Difference R_{peak}

Comments #303, #350, #351

Adee Ran, Cisco

Purpose: addressing these TBDs

Figure 163A–2—Configuration for transmitter reference steady-state voltage, pulse peak, and ERL

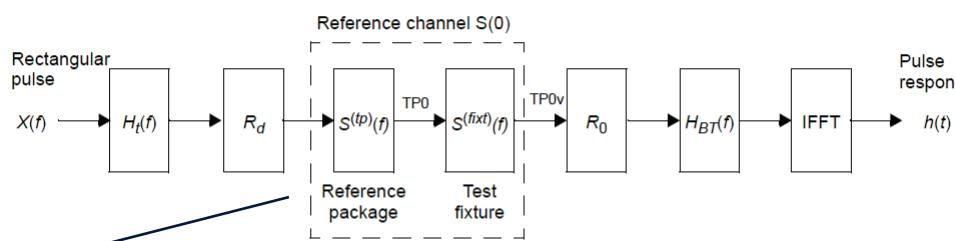
The existing method builds the reference channel from a reference transmitter + package, the measured S-parameters of the test fixture, and the measurement filter.

- For host output (179 and 176D), redefine the reference channel of Equation 163A-1 (Figure 163A-2) to include the partial host channel corresponding to the host class that the device adheres to

- For module output (176D), use the reference channel of Equation 163A-1 as it is; use the higher-loss package model (case 2, 10 mm trace)
 - For $S^{(fixt)}$, use “mated test fixtures measured according to 178A.1.3” instead of the “Measured Tp0 to TP0v”
